Re: Killarney Waste Disposal – WL217-1

## **ARTICLE 13 REQUIREMENTS WASTE LICENCE APPLICATION WASTE LICENCE 217-1**

Client	Killamey Waste Disposal Ltd					
Project Title	Killamey Waste Disposal Waste Licence Application					
Document Title	Article 13 Compliance Requirements					
Document No.	MGE0031RP0011GAL					
This Document Comprises	DCS	TOC	Text	List of Tables	List of Figures	No. of Appendices
	1	1	13	1	1	4

Title:  
**Proposed Layout for MRF Building**

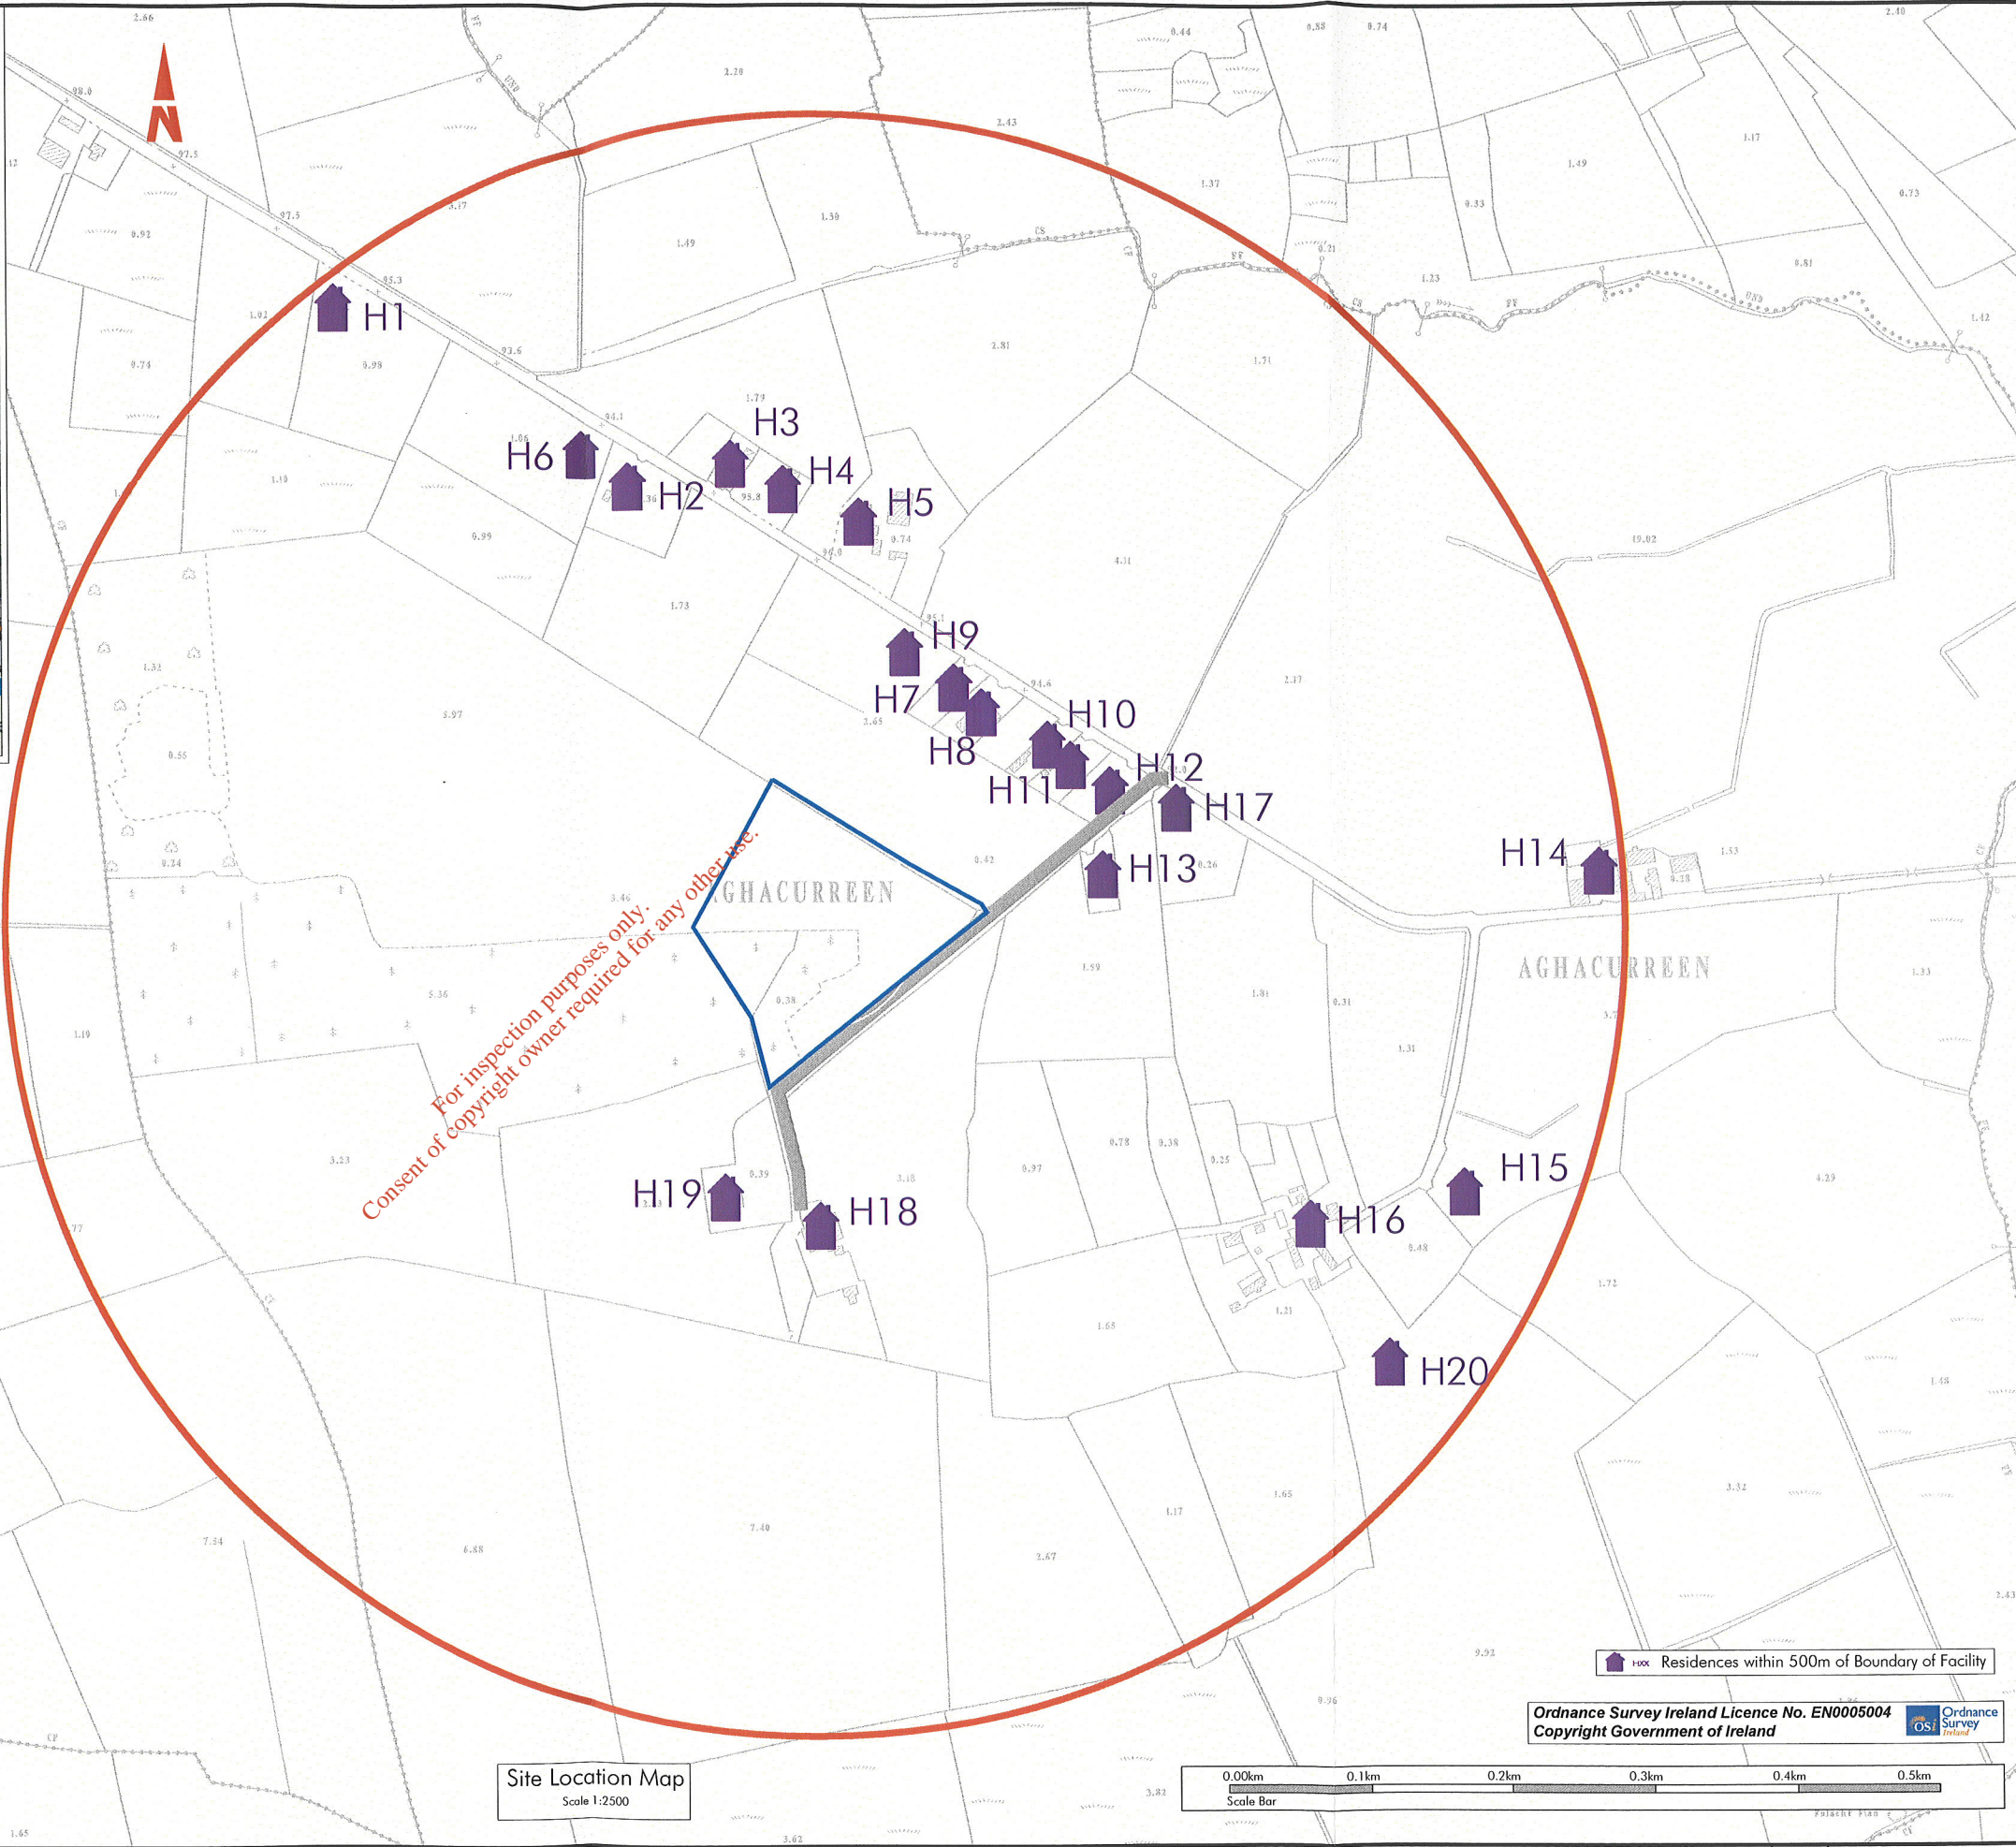
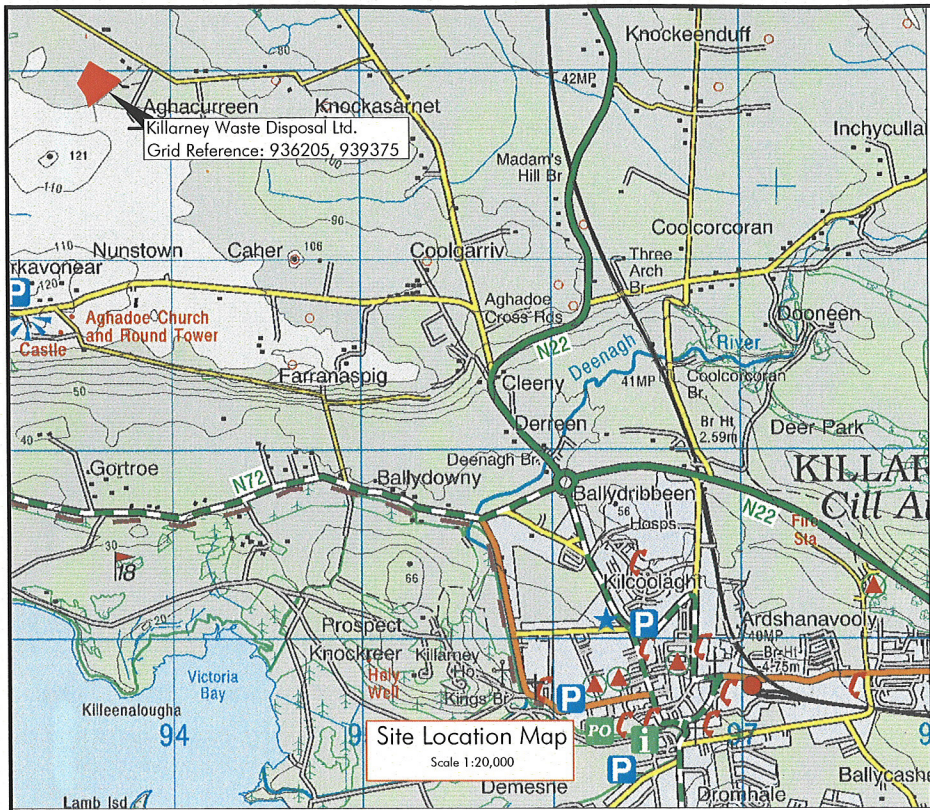
**Give details of the proposed processing plant and equipment including the size of the proposed effluent tank. Give details of the final disposal arrangements for the puraflo effluent. Provide a layout plan that includes all equipment and storage areas in the proposed development.**

The air compressors are not a significant problem and the proposed enclosure for the production compressor will be adequate to mitigate the situation. The generator has been relocated as shown in Drawing No. DG0004-01F03 thus reducing its noise impact on sensitive receptors.

increase in waste intake. It is also proposed to use a vortex dryer for the organic waste. A heat exchanger and two compressors are located outside the building and are connected to the dryer inside. A shredder shreds the organic waste before being sent for drying. An air filter traps any dust emissions which are re-circulated back into the drying process before emitting the filtered air to the atmosphere. Subsequent to drying the organic waste is sent to a pelletiser. The layout of the proposed MRF building has been updated showing the locations of all process equipment (Drawing Drawing No. DG0004-01F03). The quarantine area has been re-located. All waste is inspected on arrival in the inspection and sorting area. If any consignment is non-compliant the customer will be notified and it will be returned to the customer. In cases where the waste can not be returned to the customer it will be temporarily stored in the quarantine area.

The processing of mixed municipal waste produces an effluent. The new processing building will have effluent holding tank in the centre of the building. This precast concrete holding tank will be 6,920 litres or 1,500 gallons in capacity and will be lined with a 2.5mm thick HDPE liner. A bunding tank will be constructed around the tank which will have a capacity of 3,500 gallons. The effluent will be sent to Killarney WWTP for treatment.
